# ***Proposal of OM2 applied to P802.3bm***

Itaru Sakabe, Sumitomo Electric Industries, Ltd.

L2014-266

# Link model of transmission distance

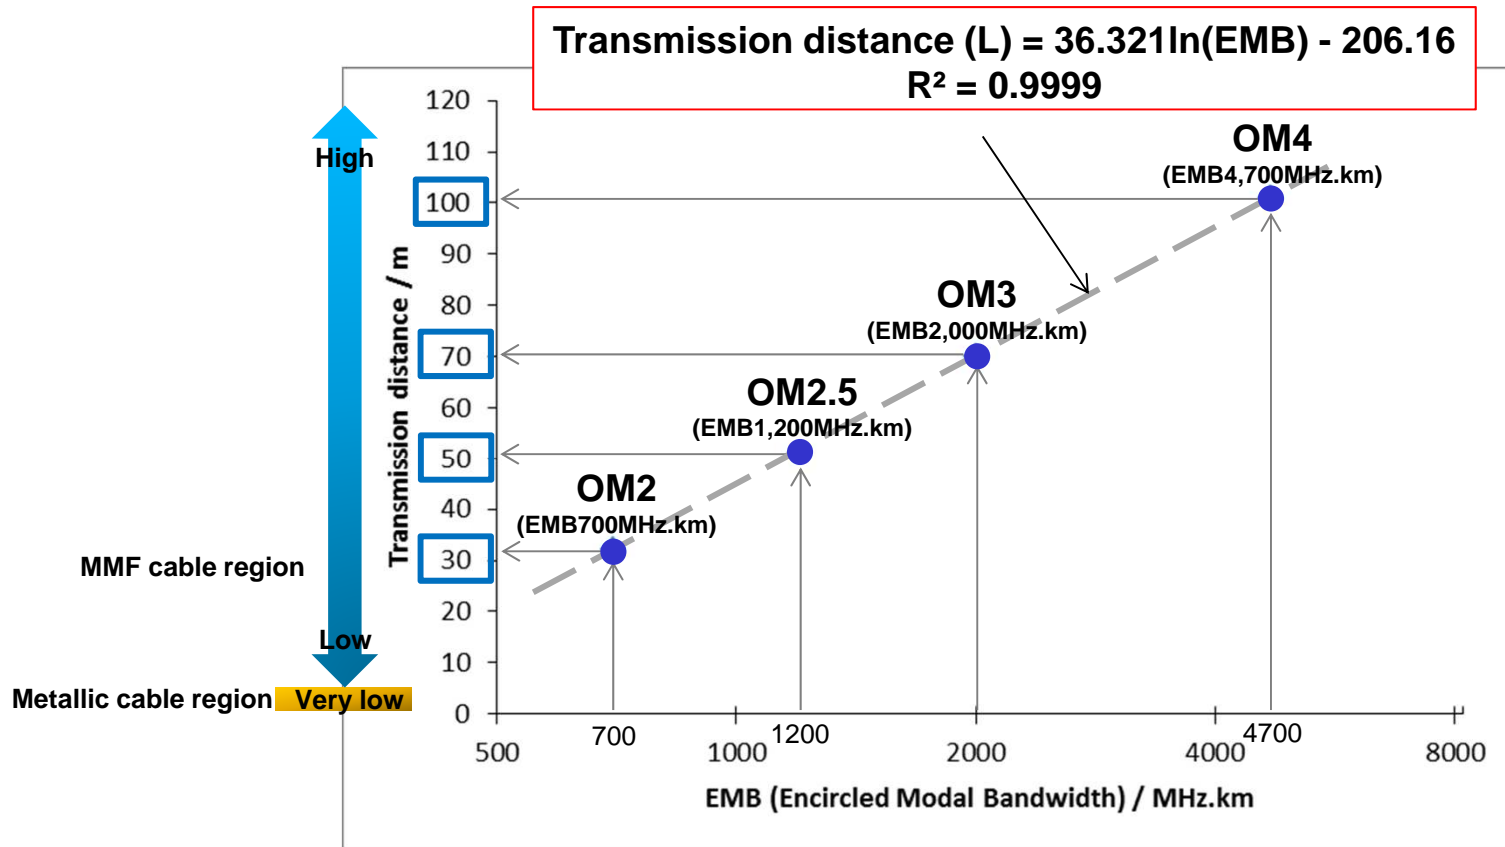
Transmission distance in 100GbE (25Gbps, 4ch) was calculated in use of Avago's spreadsheet shown below setting bandwidth as parameter.

According to Avago's spreadsheet, transmission distance in 100GbE (25Gbps, 4ch) is in proportion to logarithm of EMB shown below. OM2 with EMB of 700 MHz.km can transmit 30m. Also, OM2 with EMB of 1,200 MHz.km can do 50m which is the major transmission distance range except mega data center.
